Amendments to the Drawings:

Remarks

By this paper, the specification has been amended in paragraphs 3, 5, 9, 10, 60, 67, 69, 71, 73, 77, 92, and 93. Figures 2, 3, 4, 8, 10, and 13 are also amended. No new matter is being introduced.

FIG. 2

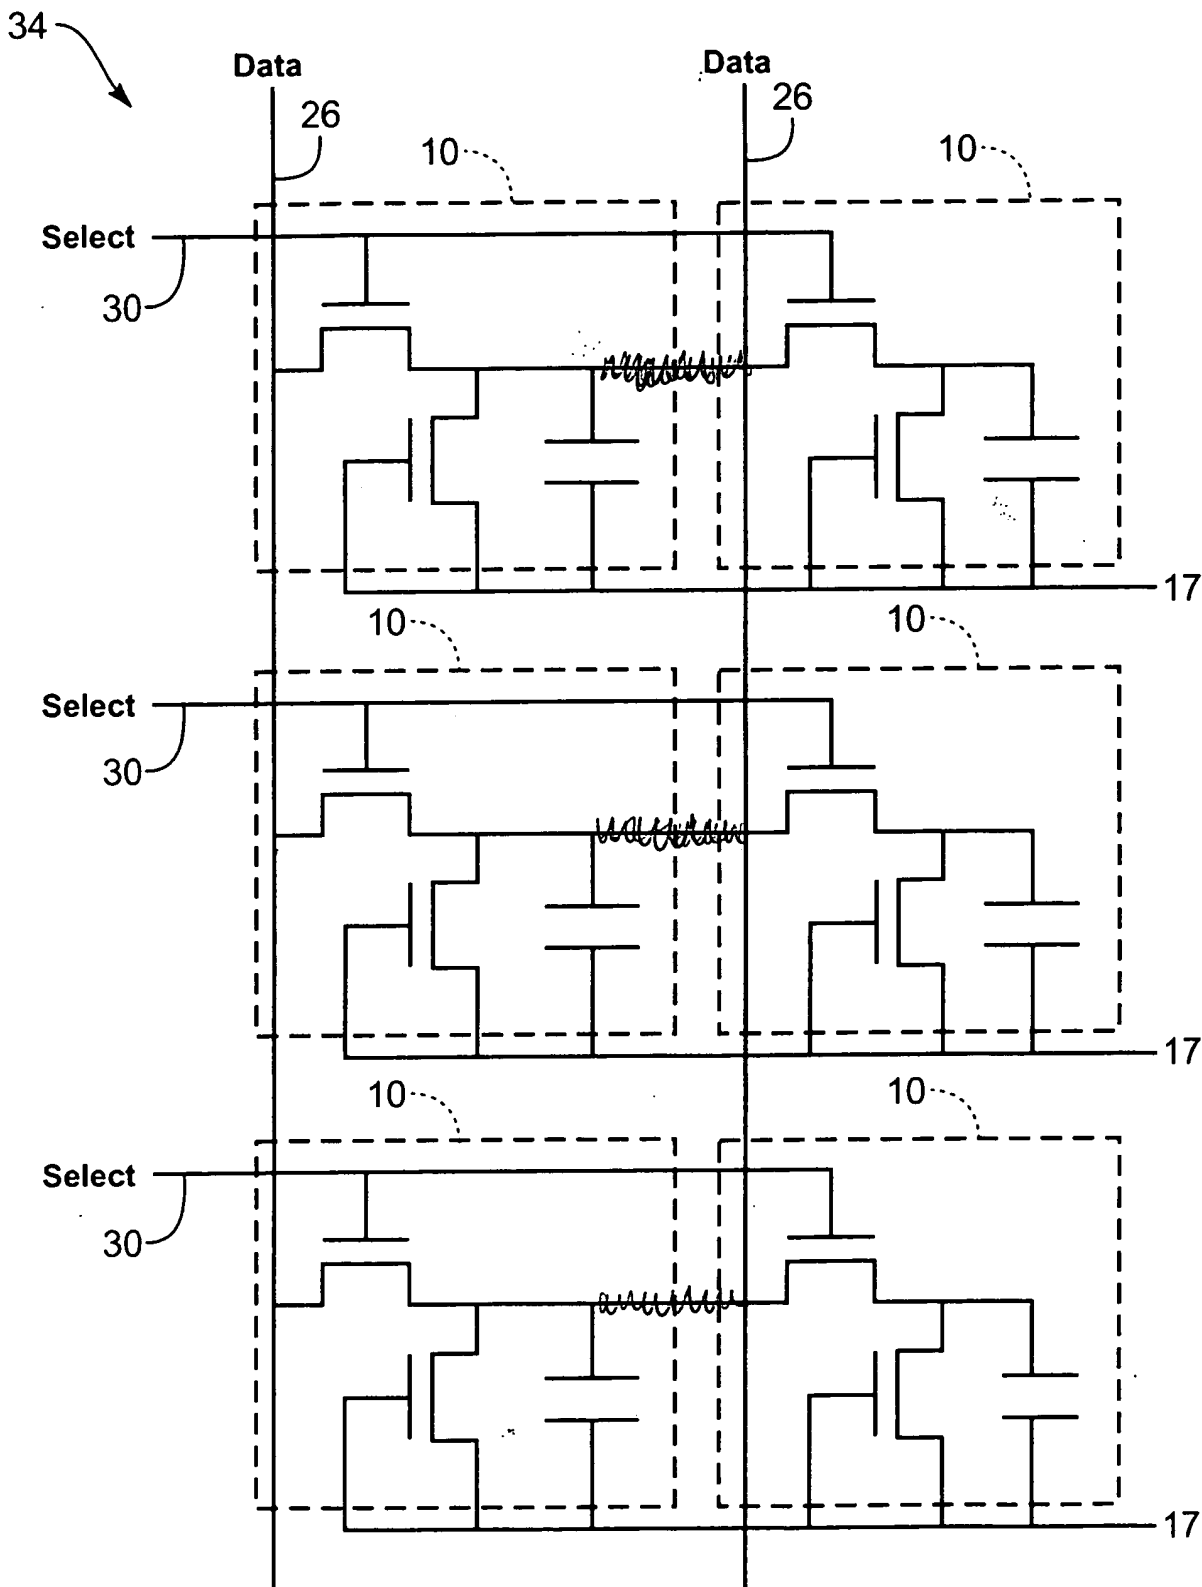
The attached sheets of drawings includes changes to Figures 2, 3, 4, 8, 10, and 13. These sheets replace the original sheets. In Figure 2, additional, erroneous lines are removed. In Figure 3, a structure is identified as "17" that was missing a label. In Figure 4, the identifier "12" has been added. In Figure 8, a missing line in the lower right capacitor in the Figure has been added. In Figure 10, extraneous identifier "124" has been deleted. In Figure 13, the chart title has been amended.
